Facility: <u>Nine Mile Point # 2</u> Examination Level (circle one): RO		Date of Examination: <u>12/06/99</u> Operating Test Number: <u>Cat A Test 1</u>	
Administrative Topic/Subject Description		Describe method of evaluation: 1. ONE Administrative JPM, OR 2. TWO Administrative Questions	
A.1	Shift Turnover	Question: 1. Given watchstanding history, medical data and training data, determine requirements to stand watches. (Active license requirements). K/A 2.1.3 - <i>Comments</i>

Nine Mile Point 2	
Category "A" - Examination Outline Cross Reference	
Operating Test Number	Cat "A" Test: 1
Examination Level	RO
Administrative Topic	A.1
Subject Description:	Shift Turnover
Question Number:	1

Turbine Building 247 Condensate Demin Valve Aisle

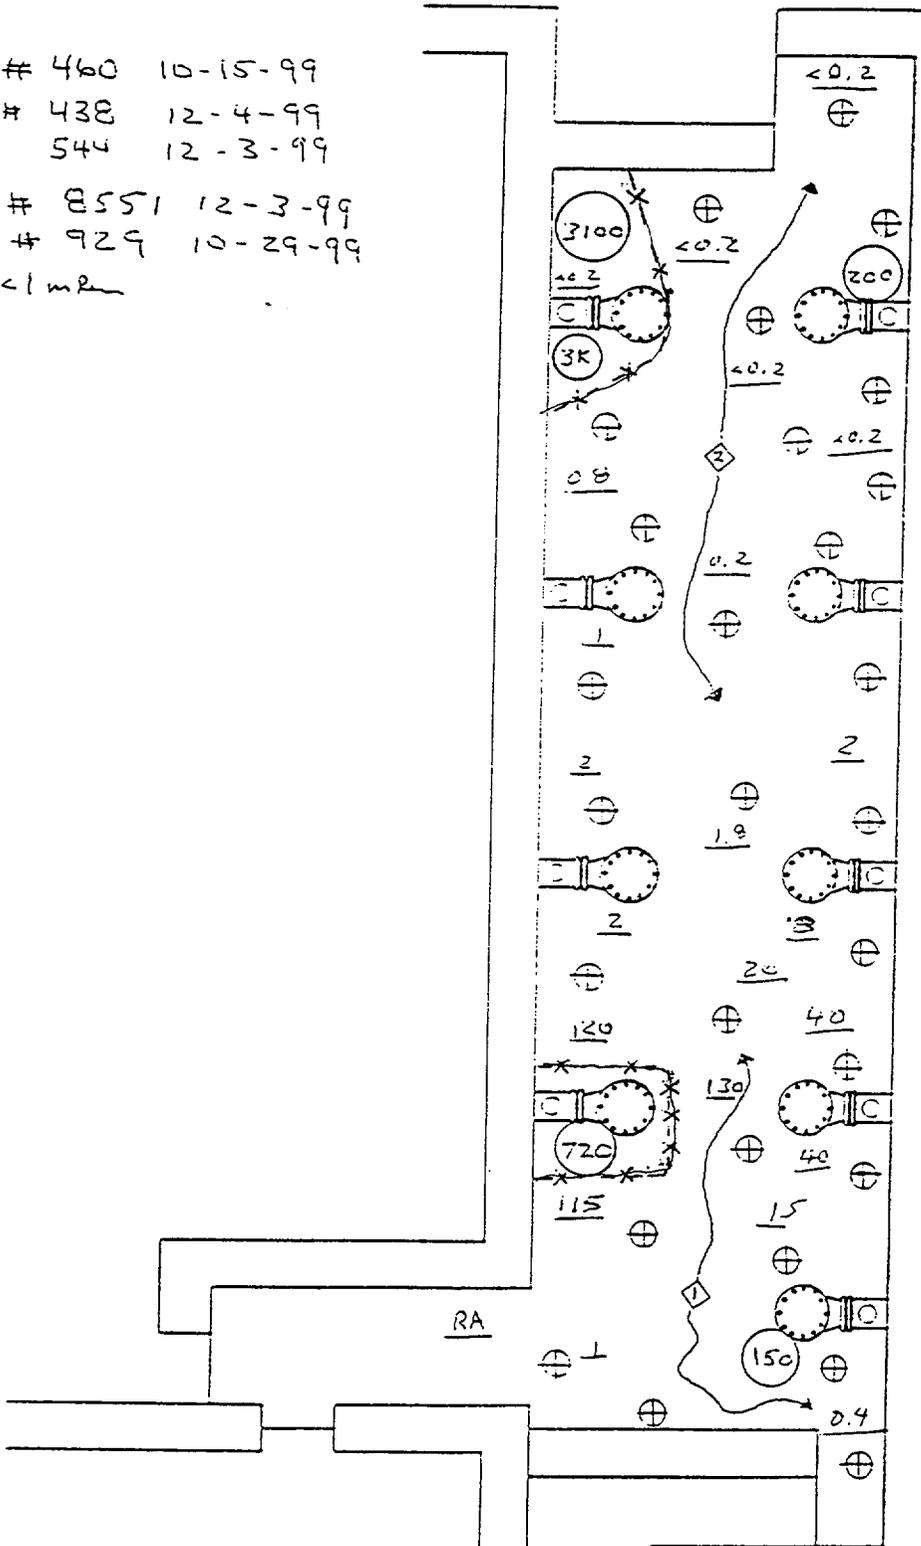
Review the attached Survey 68 for Turbine Building 277' Condensate Demin Valve Aisle and identify the radiological hazard(s), *if any. ??*

describe note.

a. Contaminated areas identified by lines with Xs on the left hand side of the room with contamination levels of (from bottom of page) 720dpm/100cm², 3000dpm/100cm², and 3100dpm/100cm².

b. High radiation levels in the bottom left hand side of the Valve aisle with radiation levels of 115mr/hr, 130mr/hr and 120 mr/hr.
"All rad levels are radiological hazards."
